Solicitation Addendum

Addendum No.: 2
Solicitation No.: 21-TA003519DJ
Project No.: 6081101
Solicitation Title: Portosueno Park South Seawall Replacement
Addendum Date: December 7, 2020
Procurement Contact: Dave Janney
Senior Procurement Agent

TYPICAL SECTIONS (1 OF 2)

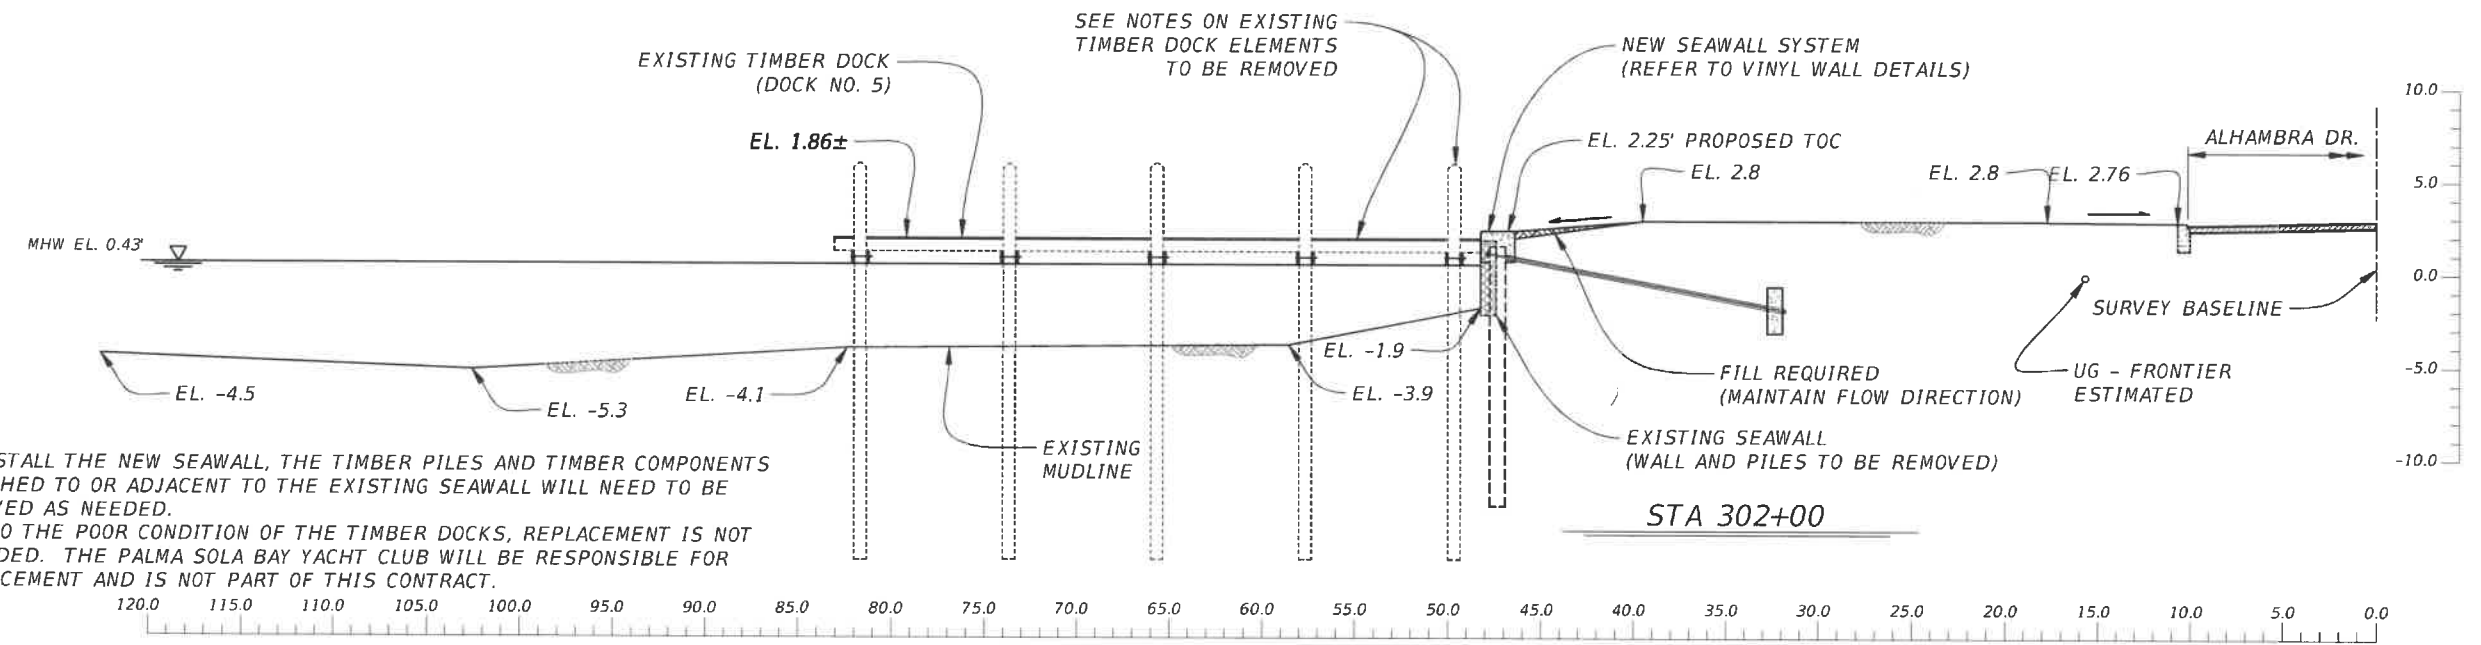
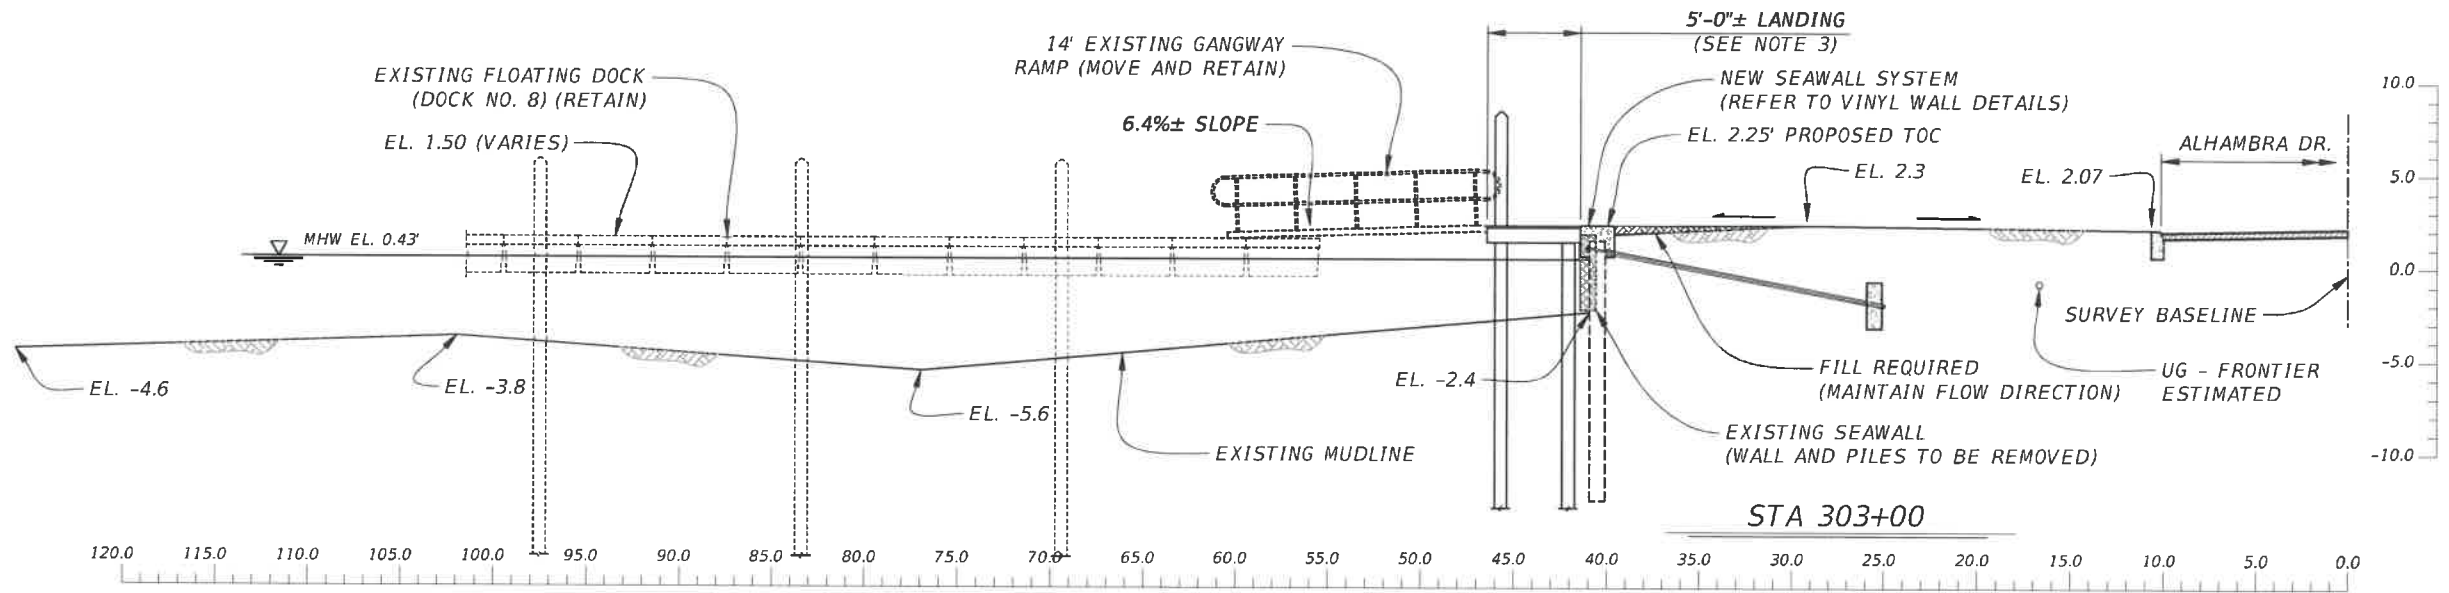
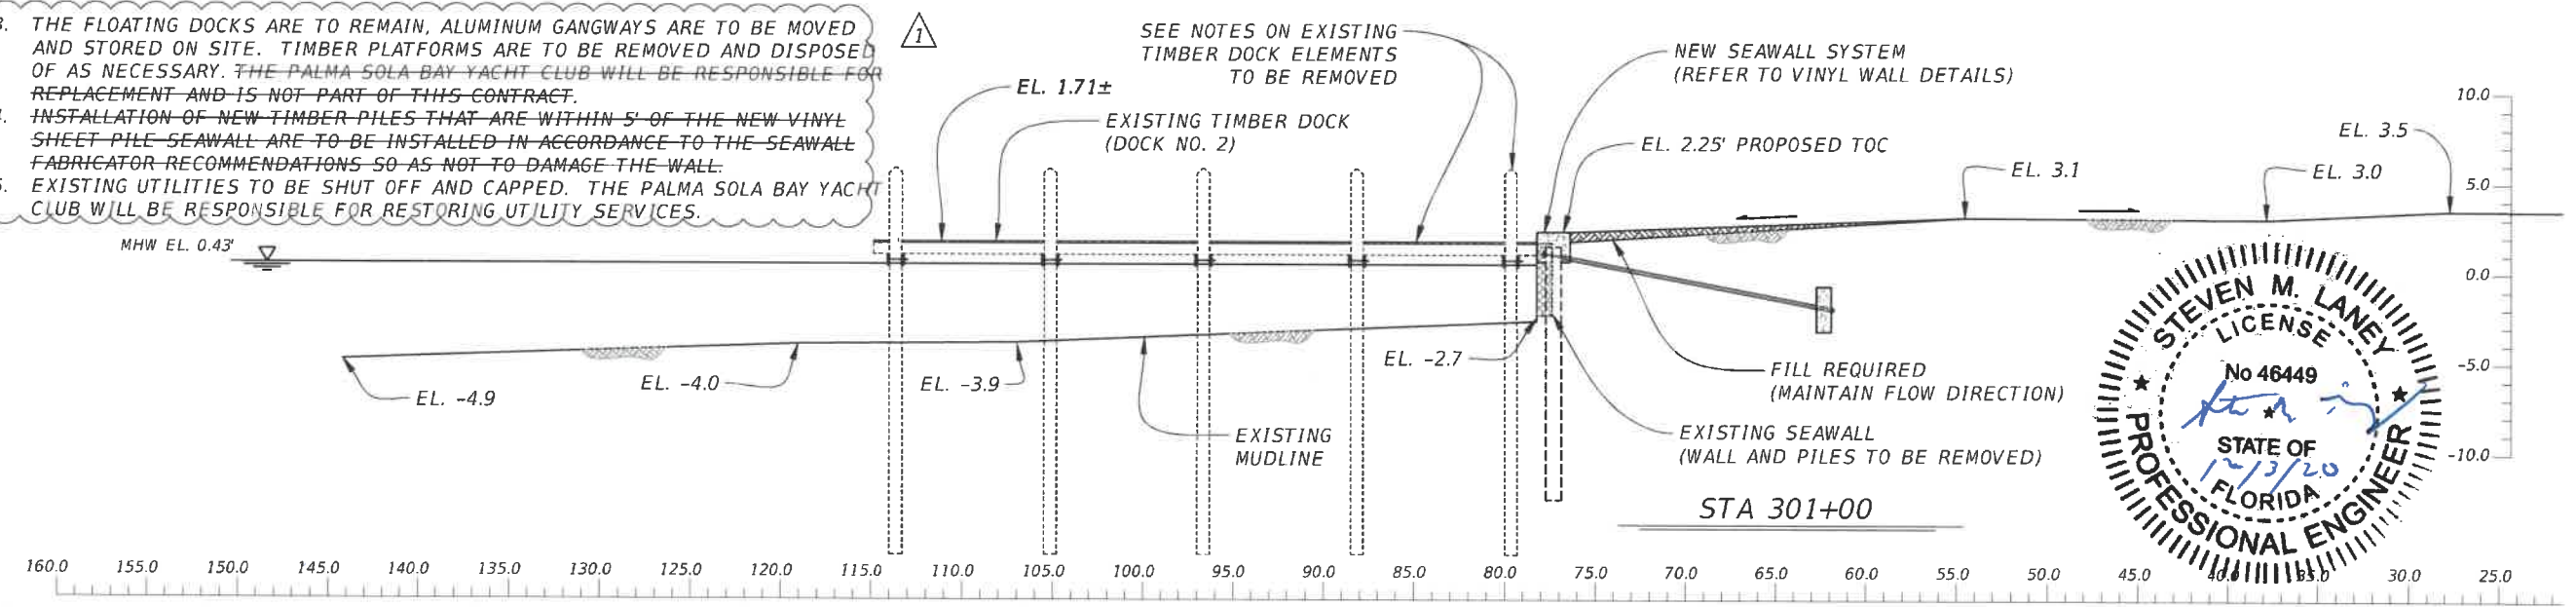
- Q26. Sheet 13 note 5 states that existing utilities are to be shut off and capped. Is this referring to electrical and water utilities to the docks? If so, please provide details on existing utilities to be capped.**

- R28. No, the gangways are to be removed and stored on site.
- Q29. Sheet 13, note 4 refers to installation of new timber piles. Please specify what size, length and timber treatment will be required for the new timber piles.**

- R26. Yes, the note is referring to the electric and water service utilities to each of the docks. The service lines are typically in 1" dia. or less pvc conduit.

- R29. Replacement of the piles is not part of the project. See Revised Plan Sheets issued with this Addendum 2 and available for download as a separate attachment.

**PORTOSUENO PARK
SOUTH SEAWALL REPLACEMENT
DETAILS (1 OF 3)**

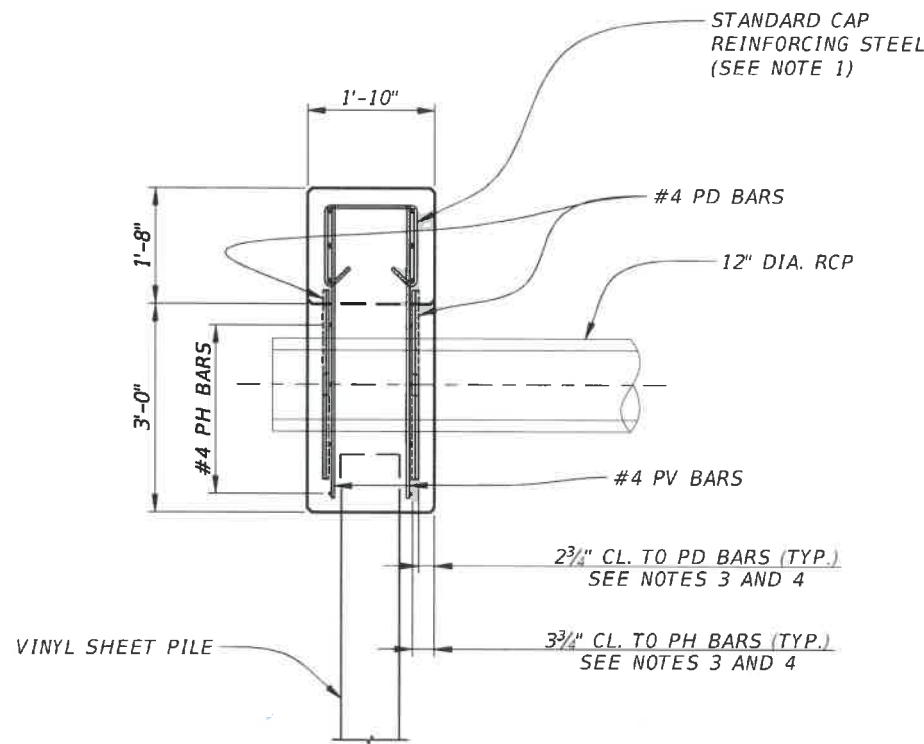
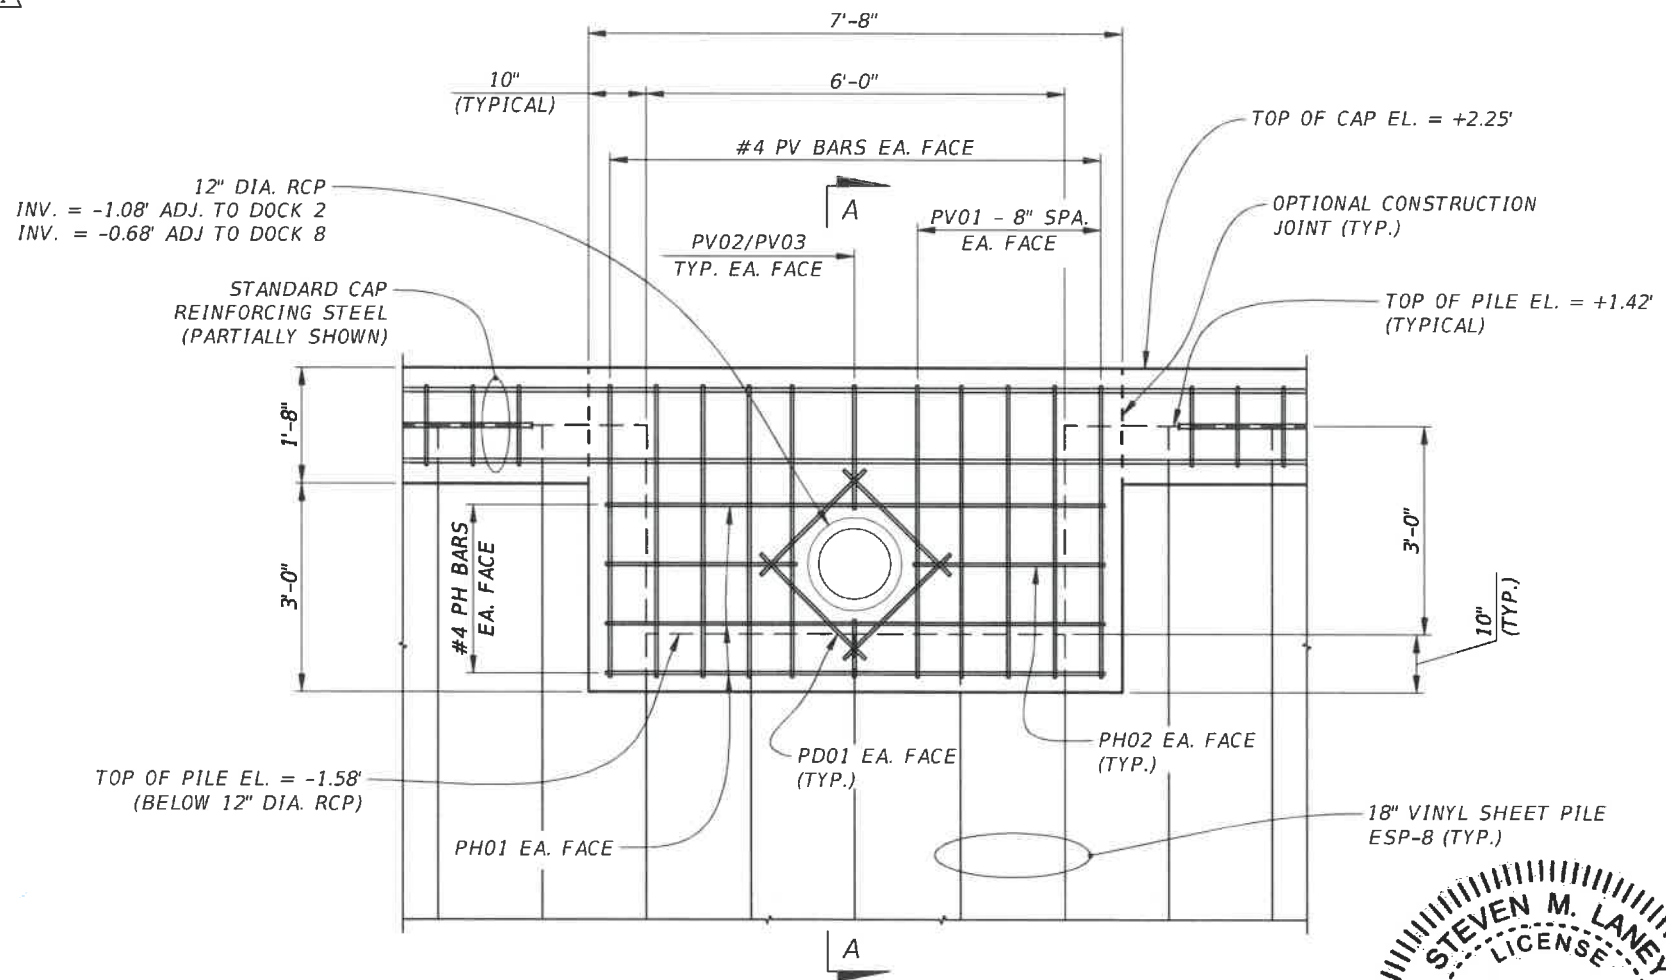
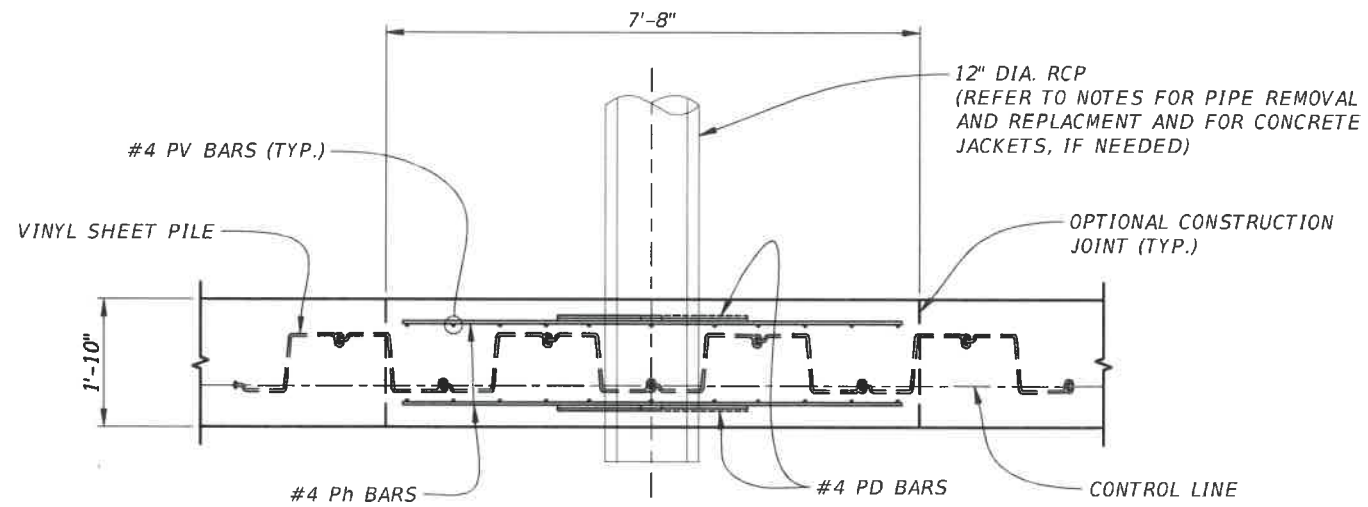
- R30. The gangways are to be removed and stored on site.
- Q31. Sheet 15, note 5 c refers to re-installation of the pipe. Please provide a quantity of new pipe to be included in the bid price if the existing pipe is not usable. Alternatively, we request that the Owner address the new pipe if needed via change order so bidder's can exclude this from the bid price and plan to reinstall the existing pipe.**

- Q32. Sheet 15, note 7 states that payment for new pipe material if required will be paid under pay item # 430-74-112. However there is no pay item in the bid pricing form with this number. Please provide a bid form that includes this pay item or direct bidders to include the price under a different pay item on the bid form.**

- R31. If it is determined that the existing pipe is not re-usable, a new section of pipe will be addressed in a Field Directive. The Contractor does not need to bid on installing a new section of pipe. Note that the existing pipe for both locations is 12" Dia. RCP and only the section adjacent to the wall would need to be replaced if found to be damaged.

- R32. If it is determined that the existing pipe is not re-usable, a new section of pipe will be addressed and paid for under a Field Directive.
- Q33. Sheet 23 and 24 have details that are blurred and difficult to read. Please provide a clear image of these sheets for clarification.**
